Access Compliance Report

Public Rights-of-Way

(Curb Ramps)

Intersection ID: 7082	Main Street: CANNON_AV	Cross Street: N_GRAHAM_ST	Location: E
ADA ID: D62A94C7F6C2	Ramp Type: Perp	Initial Pass/Fail: Fail	Overall Compliance: No
Severity Score: 12.5			
Codes/Mitigation Info/Possible Solution		Field Measurements/Component Compliance

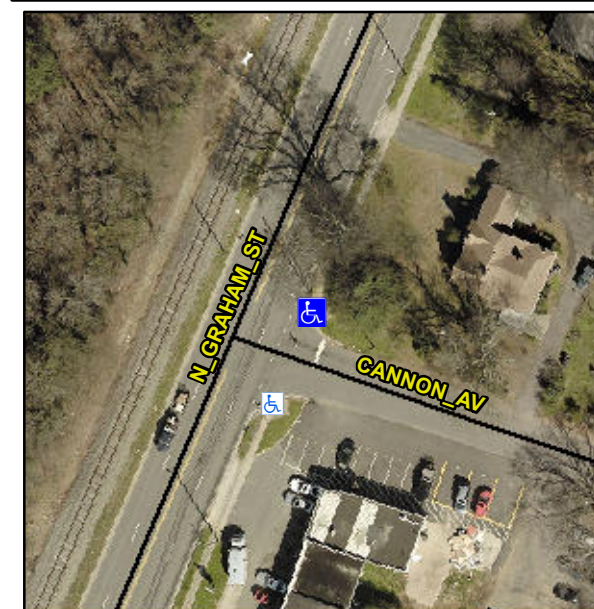
Not Found, R304.2.2

Compliance	Description	Data	Compliance	Description	Data
N/A	Ramp Length (in)	34.0	No	Ramp Slope (%)	8.9
Yes	Ramp Width (in)	51.0	Yes	Ramp XSlope (%)	0.5
N/A	Flare Type LT	N/A	N/A	Flare Type RT	N/A
N/A	Flare Slope LT (%)	N/A	N/A	Flare Slope RT (%)	N/A
N/A	Flare Traversable LT?	N/A	N/A	Flare Traversable RT?	N/A
N/A	Landing Length (in)	N/A	N/A	DWS Provided?	N/A
N/A	Landing Width (in)	N/A	N/A	DWS Contrast?	N/A
N/A	Landing Slope (%)	N/A	N/A	DWS Length (in)	N/A
N/A	Landing X Slope (%)	N/A	N/A	DWS Full Width?	N/A
N/A	Landing Curb? (Y/N)	N/A	N/A	DWS Offset (in)	N/A
N/A	Shared Landing?	N/A			
N/A	Gutter Ponding?	N/A	N/A	Gutter Slope (%)	N/A
N/A	Gutter Lip Ht (in)	0.5	N/A	Gutter X Slope (%)	N/A
N/A	Painted X Walk1?	No	N/A	Painted X Walk2?	N/A
	X Walk 1 Direction	To SW		X Walk 2 Direction	N/A
N/A	X Walk 1 Width (in)	N/A	N/A	X Walk 2 Width (in)	N/A
	X Walk 1 Slope (%)	0.4		X Walk 2 Slope (%)	N/A
	X Walk 1 X Slope (%)	1.1		X Walk 2 X Slope (%)	N/A

Remove & Replace Entire Ramp.
